Project Name: Village At Mill Pond - Master Plan Design Criteria Amendments

Project Description: Amendments to the Design Criteria for the Village At Mill Pond - Master Plan.
See attachment for proposed amendments.

The Village At Mill Pond Design Guidelines - Explanations

THE MAGNOLIA
(LOT 26)

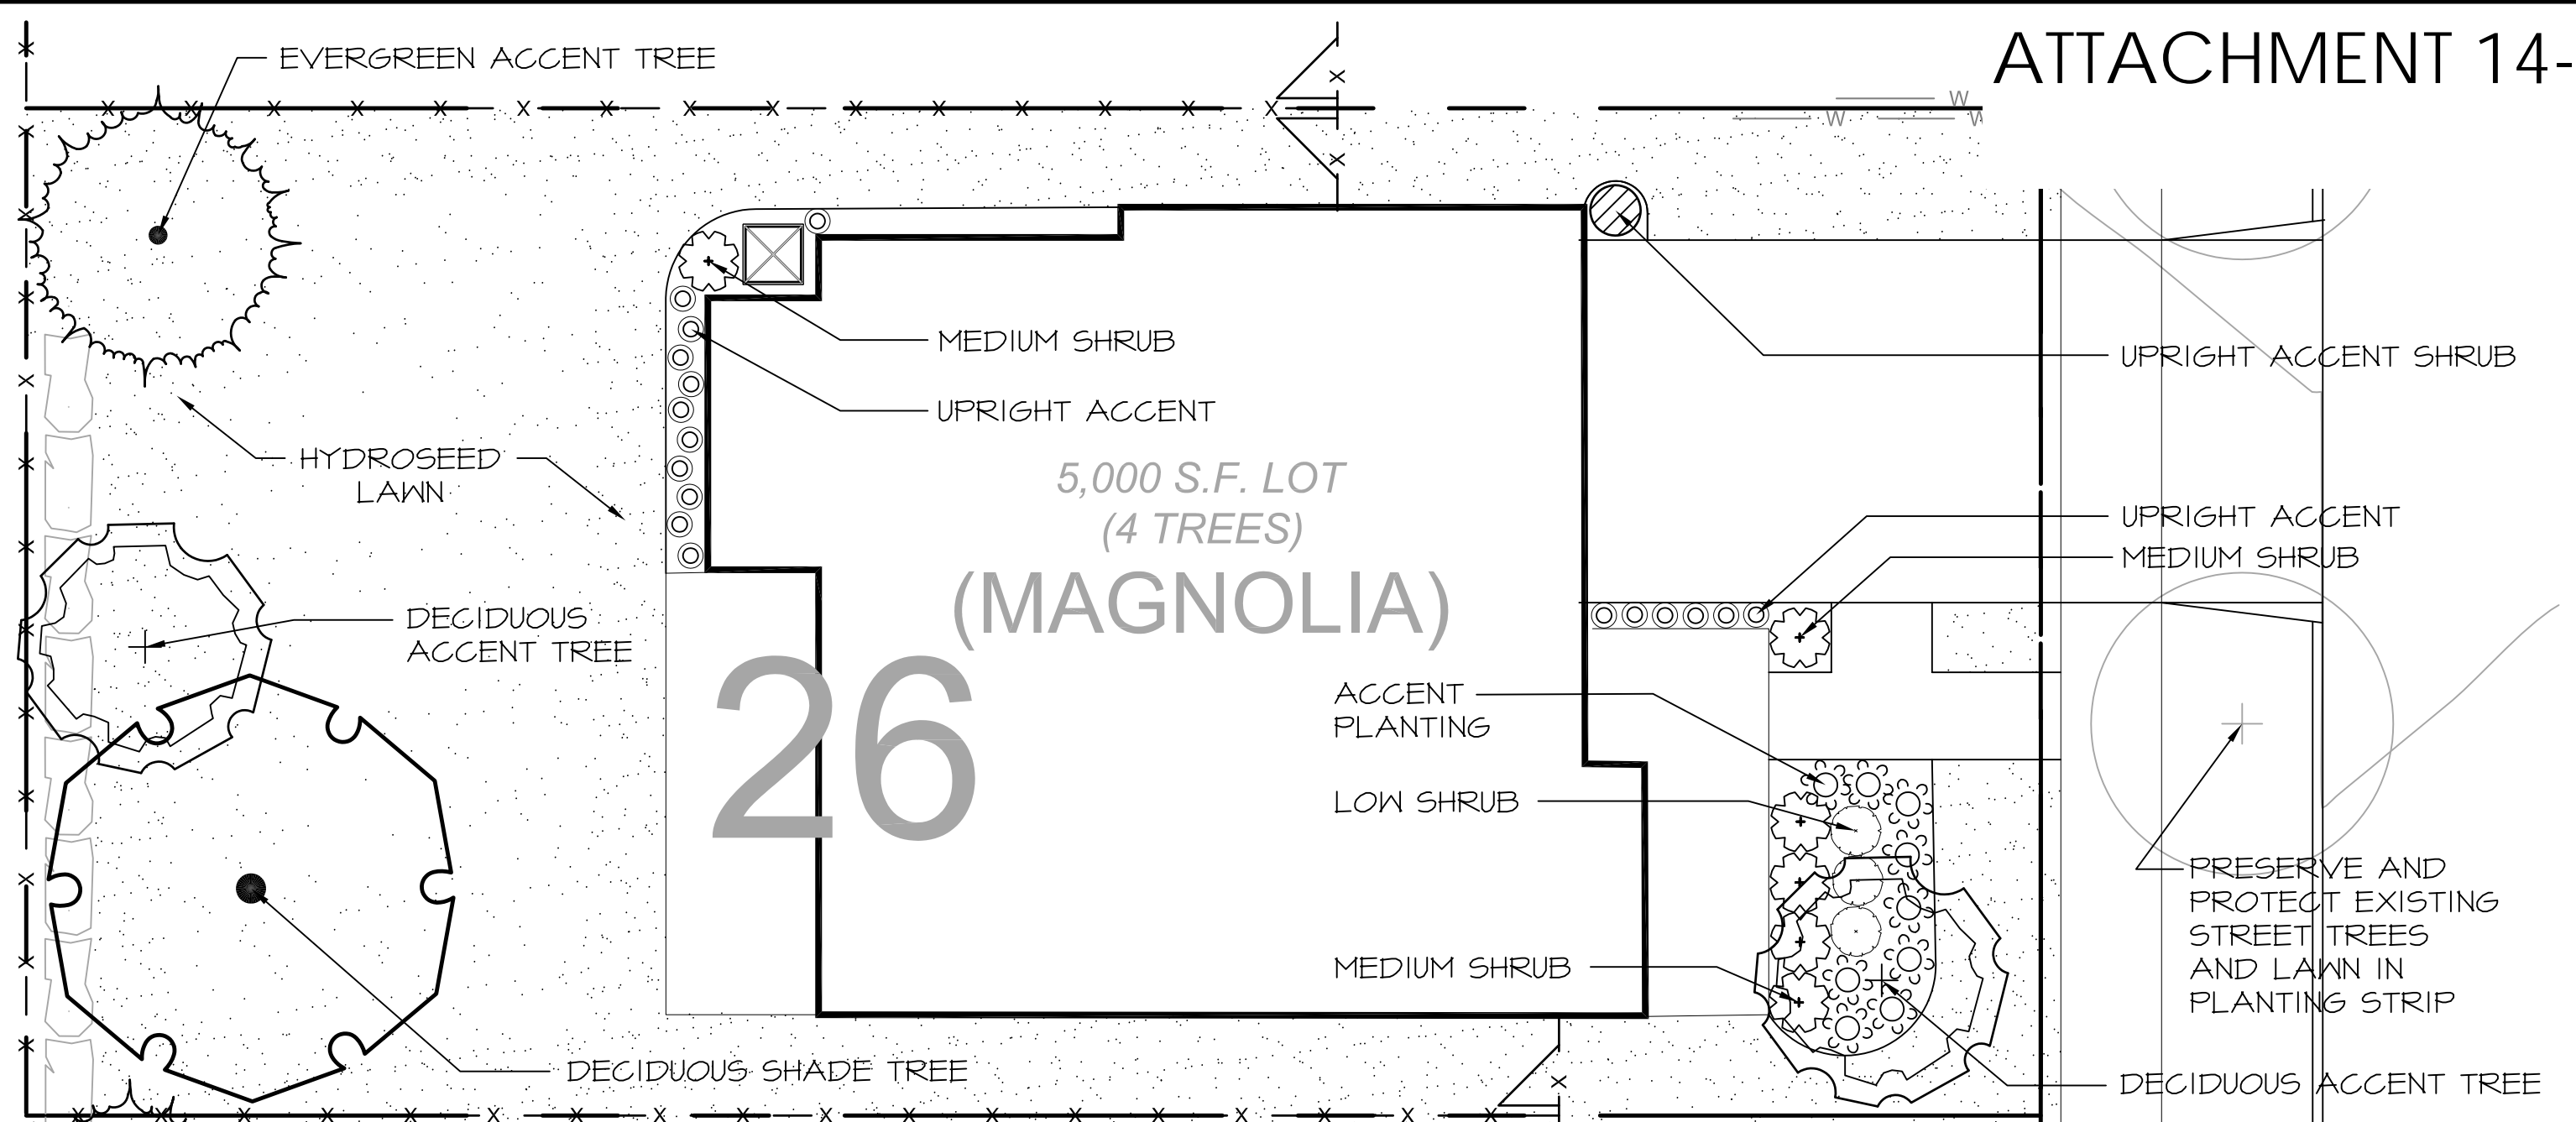
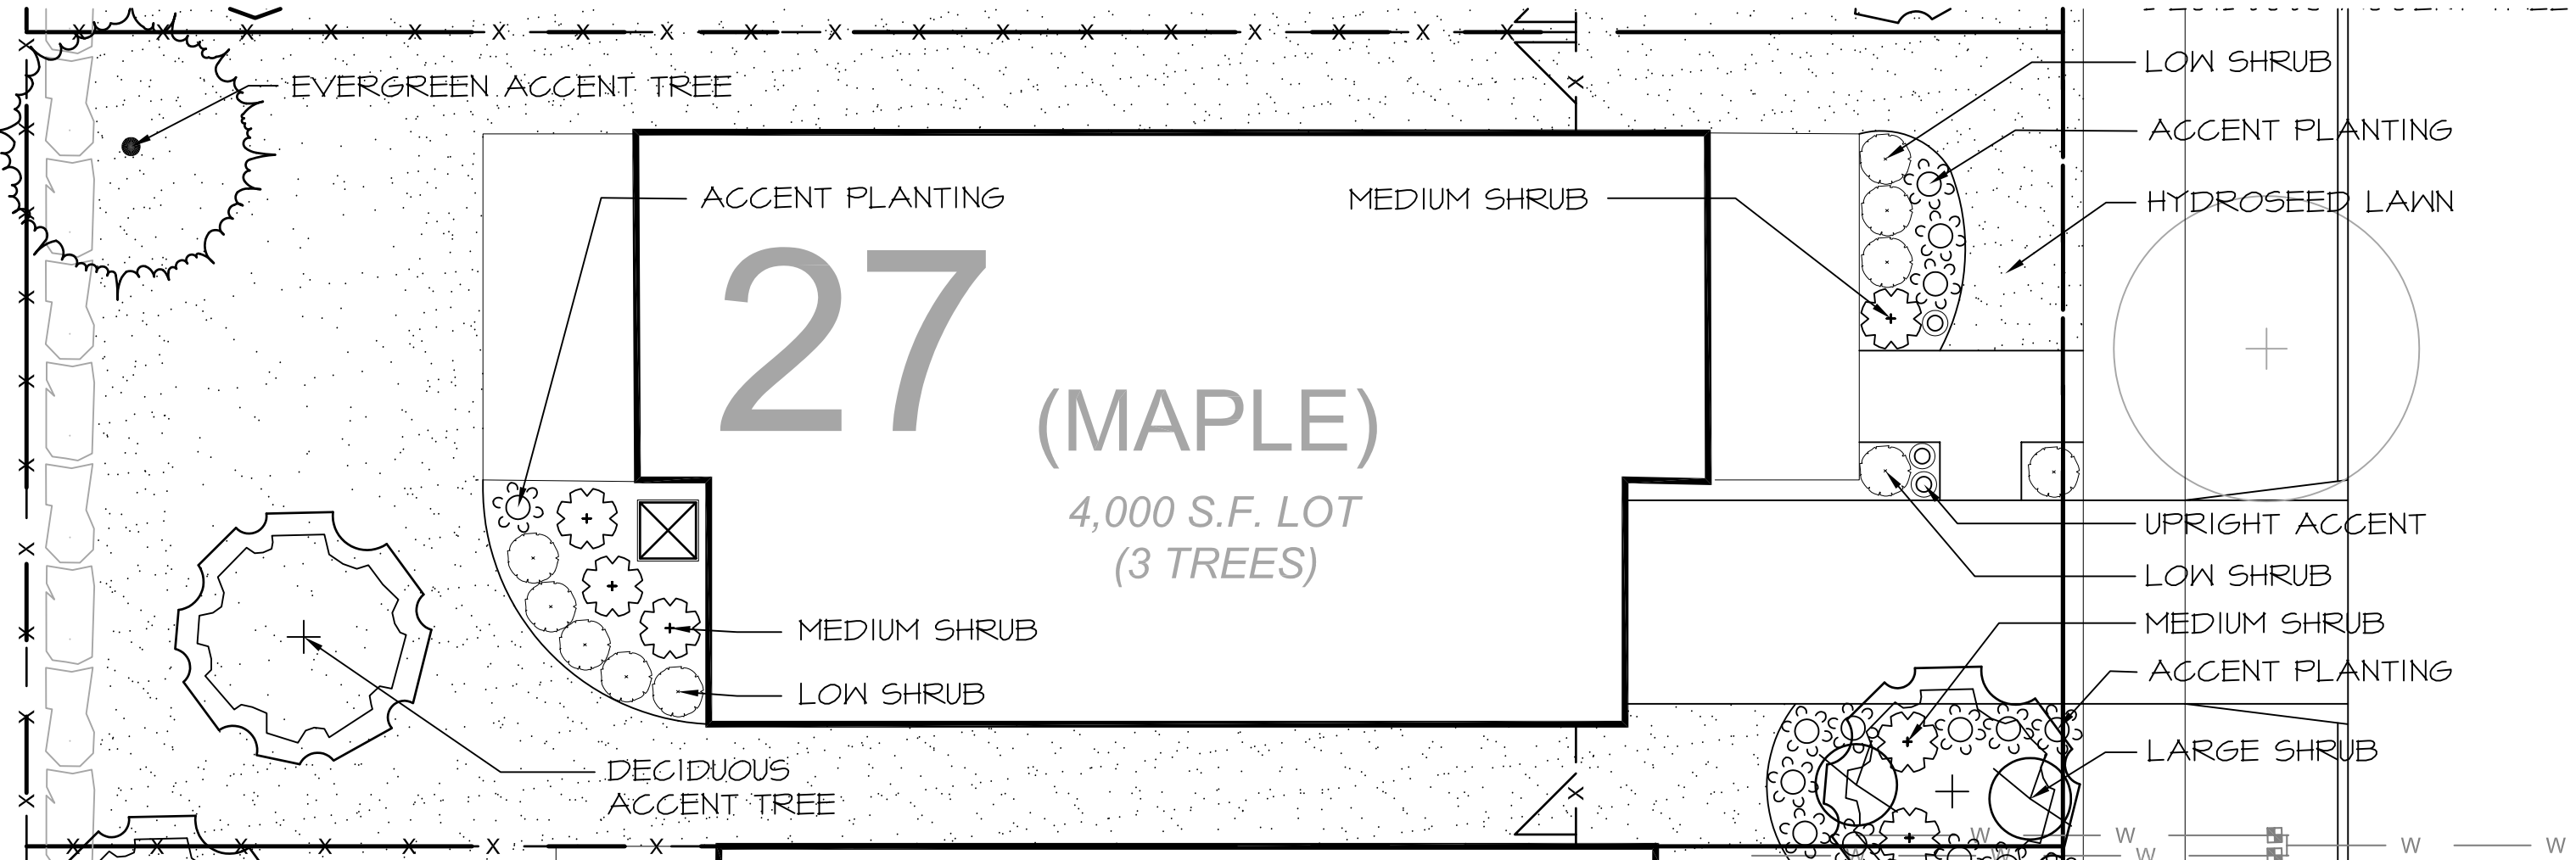
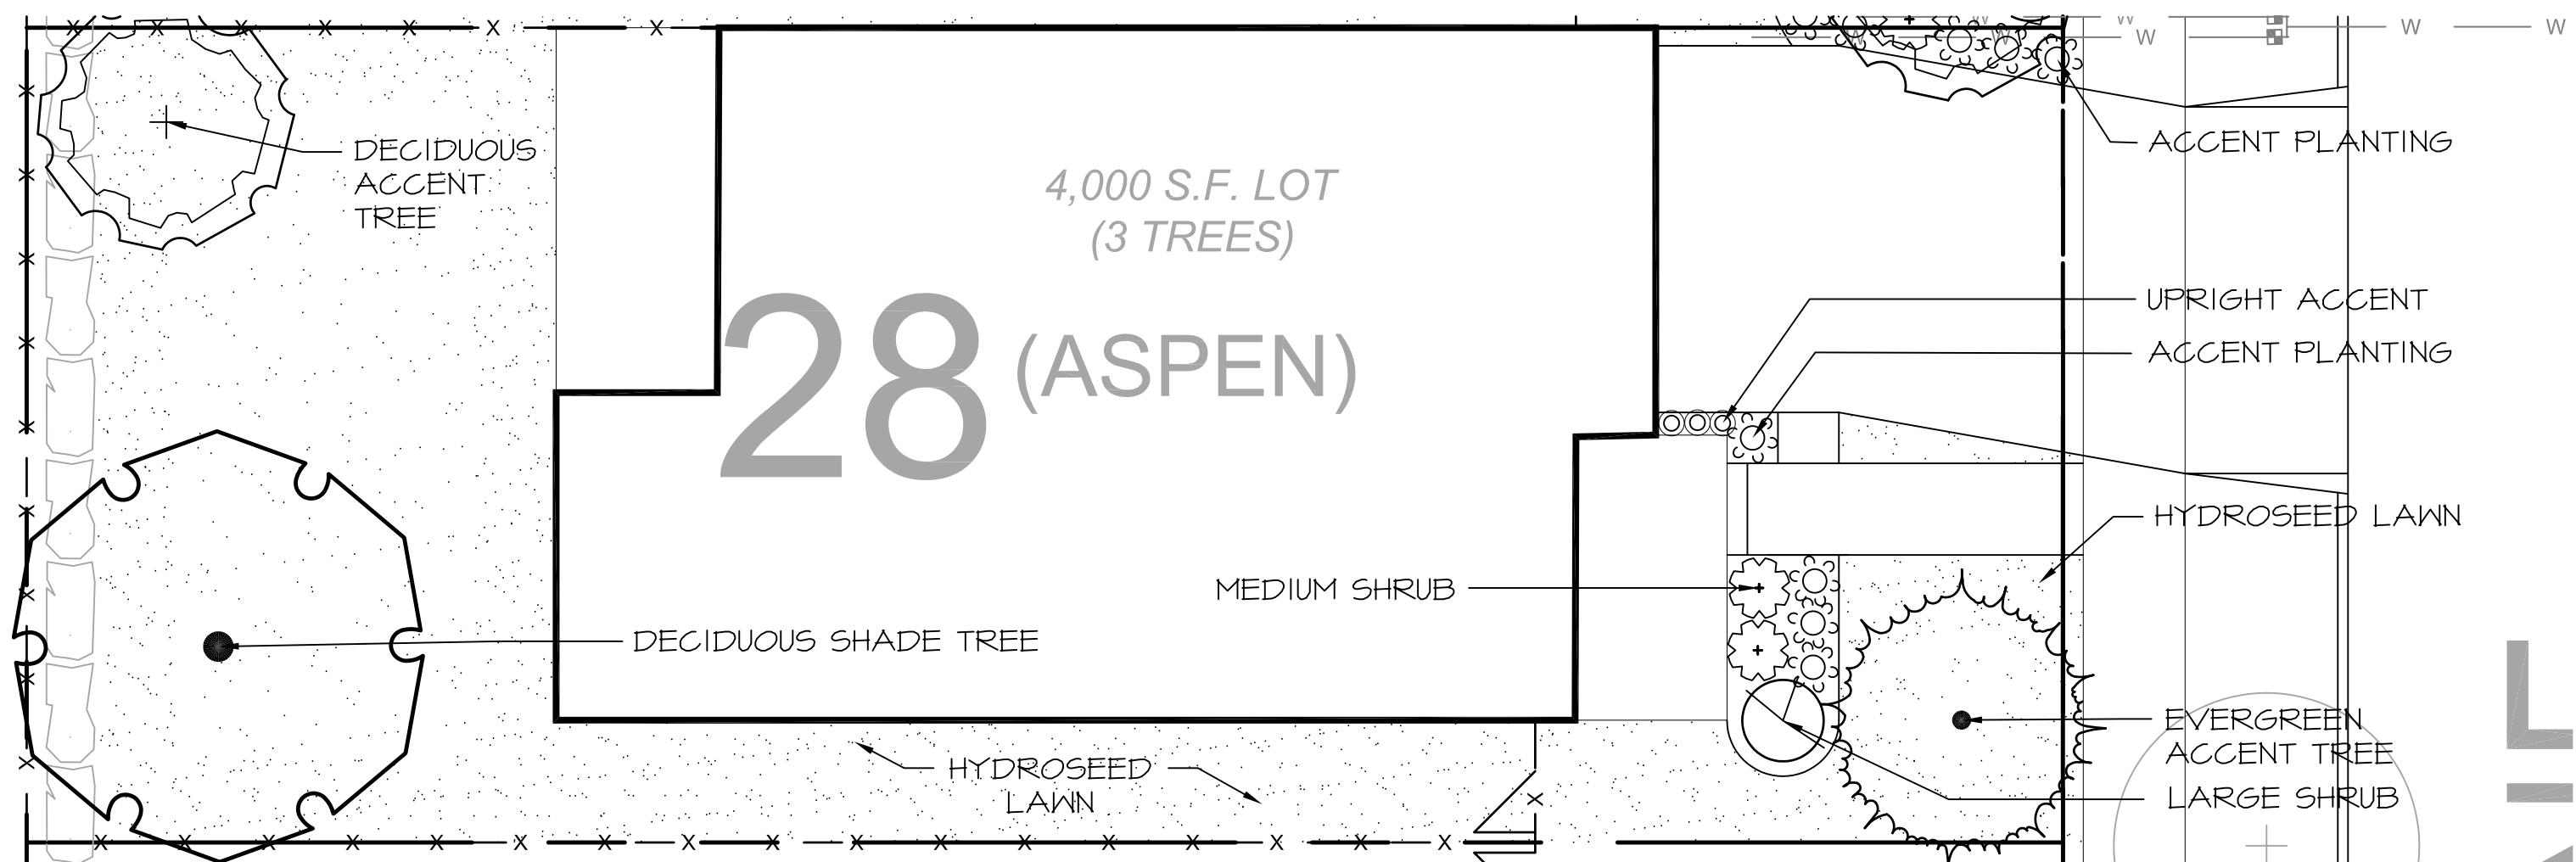
- Develop landscape in layers. ~~Low at street level and then~~ **Provide low landscaping near sidewalks**, foundation plantings at foundation, ~~with~~ **and** specimen trees as intermediate layer.

This amendment clarifies the location for plantings. The intent is not to require plantings to line the entire length of the street, it is simply a criteria for size of plantings at each specific zone around the lot.

See Attachment 14-A through 14-G for example landscape plans and planting types for typical model houses

LANDSCAPING PHOTOS FROM EXISTING SITE

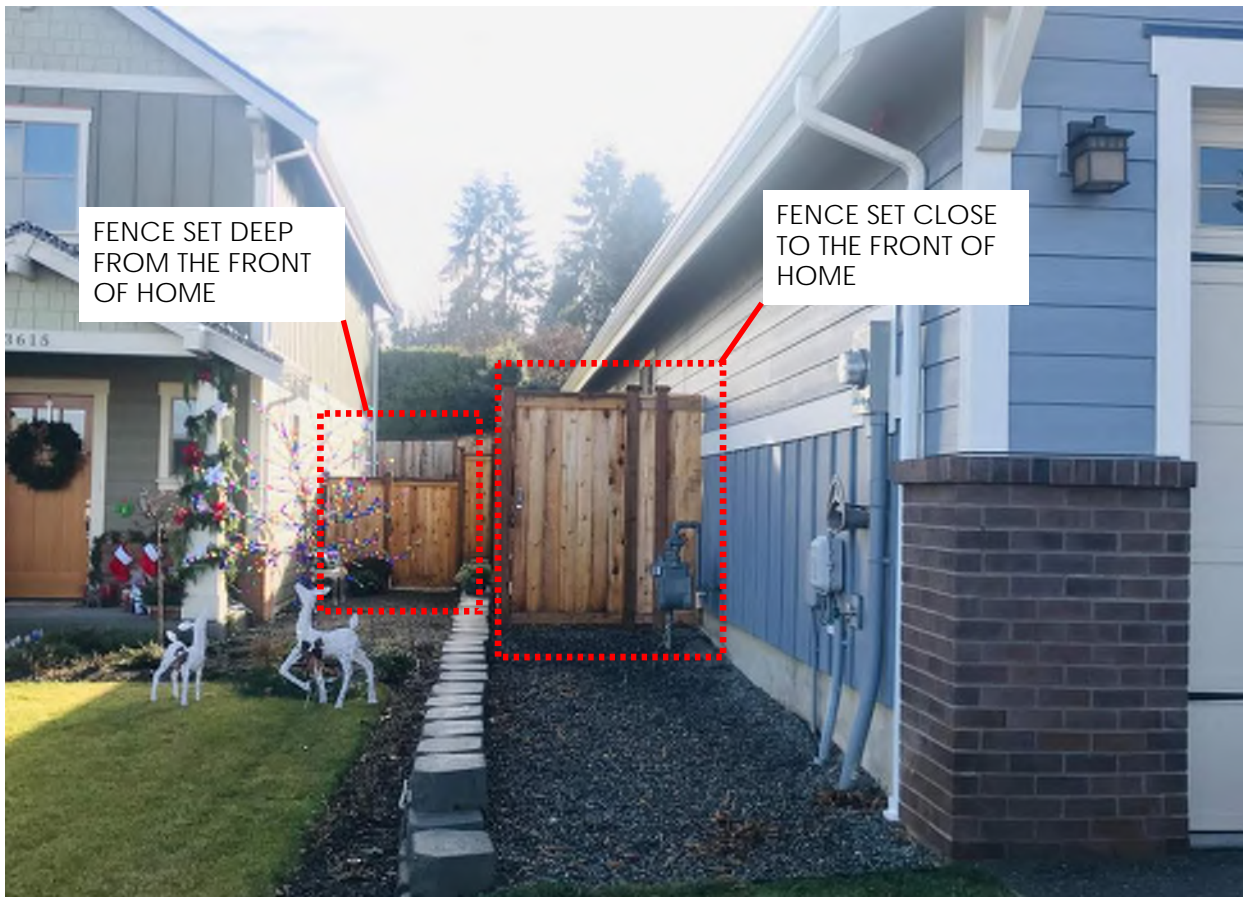
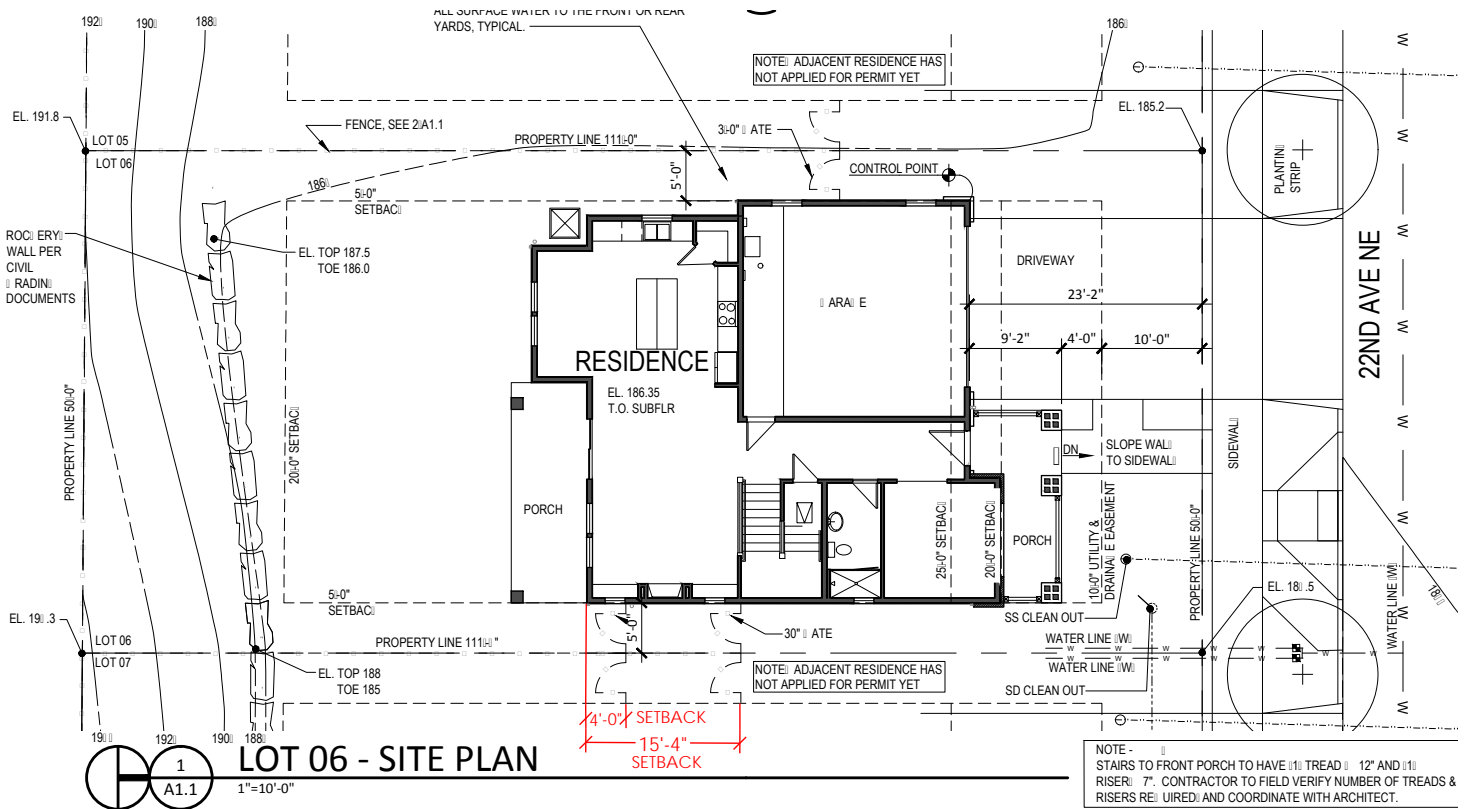
See Attachment 14-H for photos of landscaping at the existing site

Example of 5:12 slope roof below with a 6:12 slope roof above

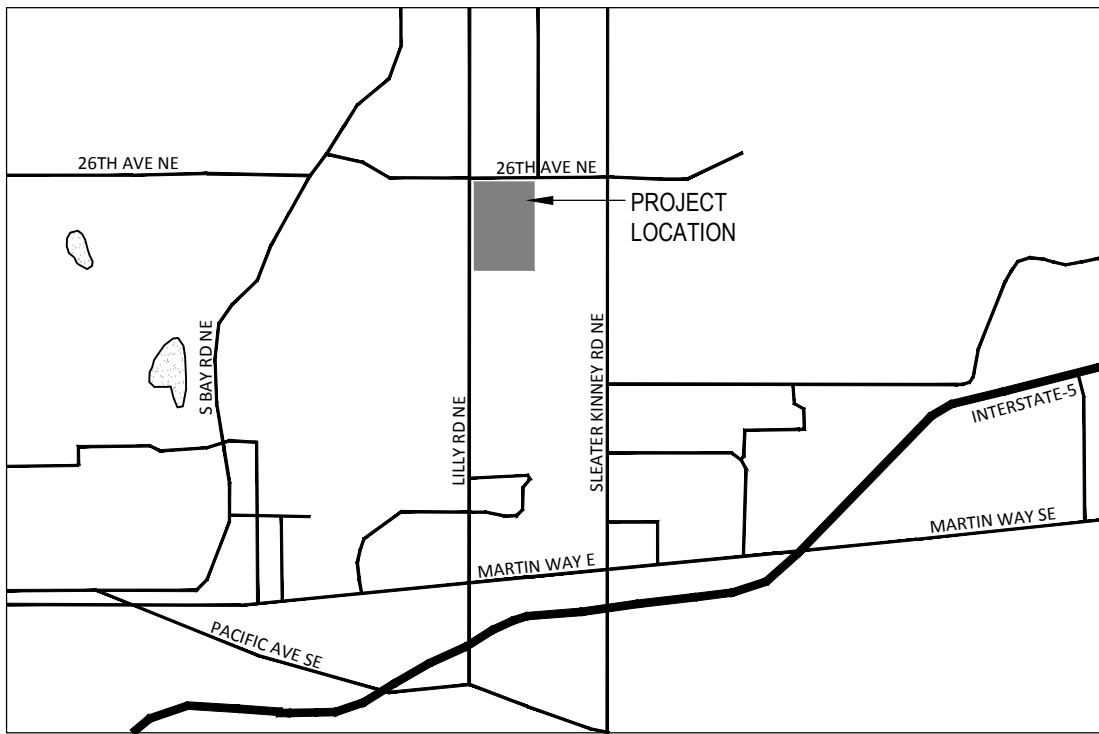
By adding this criterial a secondary roof slopes at rear or side of the single-family homes could be of a lower slope to accommodate variety in massing allow for flexibility to adjust to various floorplan layouts. These slopes would be perpendicular (90 degrees) to the primary slope and would not be allowed to face the street or open public areas.

- Reduce gable at rear entrance (off alley) from 6:12 to 5:12.
- Reduce scale of rear facade
 - provide greater flexibility in floor plan layout
 - Provide greater variety in massing along vehicular drive access.
